REMARKS

In the Drawings

FIG. 18b

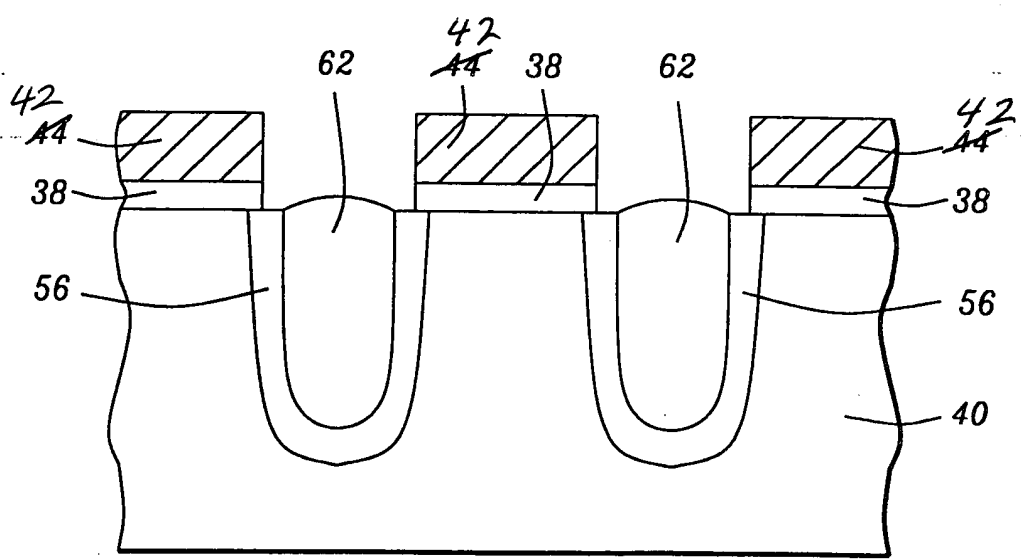
Please replace Fig. 18b with the attached replacement sheet, in which reference number “44” is changed to “42.” Support for this corrections can be found at least in page 8, lines 19-20 of the application. Also, the specification is amended to delete reference number 64, as it is not shown in the drawings. Applicant submits that no new matter has been added.

Please replace Fig. 18b with the attached replacement sheet, in which reference number “44” is changed to “42.”
